NUCLEAR ENERGY
ENGINEERING
DIVISION

SUBJECT: Reliability and Response Action Time For The General Electric
Test Reactor (GETR) Scram System - License TR-1 - Docket 50-70

Attached are responses to questions raised in a meeting on July 30, 1980
with members of the NRC staff.

FIGURE 1. MODIFIED SEISMIC SYSTEM BLOCK DIAGRAM

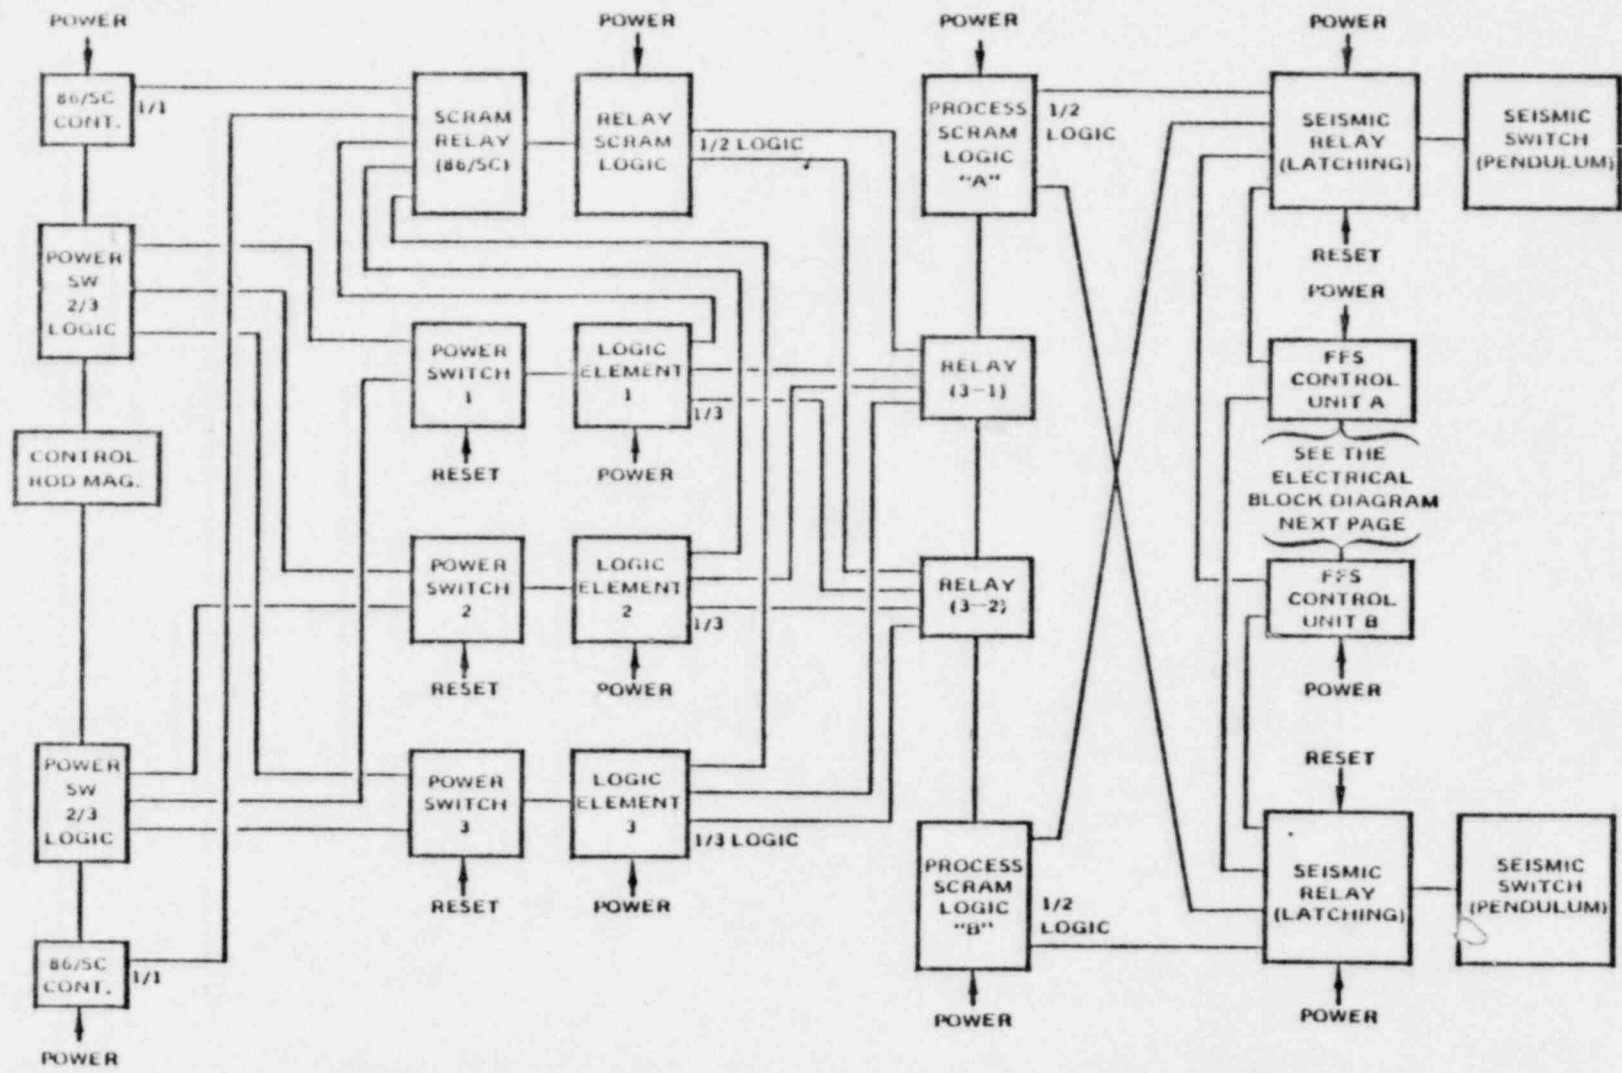
Comment 1: Discuss the reliability of the scram circuitry.

The block diagram for this system that includes the sensor that produces a scram for seismic events is shown in Figure 1. The scram system is actuated by either one of two pendulum-type seismic switches. Each switch actuates when the pendulum moves 0.71 mm in any horizontal direction, which corresponds to about a Modified Mercalli IV value (0.01g-0.03g). When actuated, each switch sends a signal to separate thyratron tubes, each of which drives separate relays. These relays drive the seismic relays (latching). In turn, each seismic relay (latching) sends two scram signals to the process scram logic and to each of two separated, redundant Fuel Flooding System control units. The process scram logic consists of process relay contacts connected in one out of two (or two of three) configurations. The associated relays are energized during normal operation. A seismic trip will de-energize relays 3-1 and 3-2. These relays send signals to the three reactor protection system logic elements, and to the relay scram logic as shown. The relay scram logic system directly interrupts the control rod magnet circuit and sends a scram signal to the protection system logic elements. The logic elements trip their associated power switches when any one of the three input signals calls for a scram. When any two of three power switches indicate a scram, the magnet circuit is interrupted. Thus, control rod latch magnet current is interrupted either directly via the relay scram logic system or by action of the logic elements and power switches.
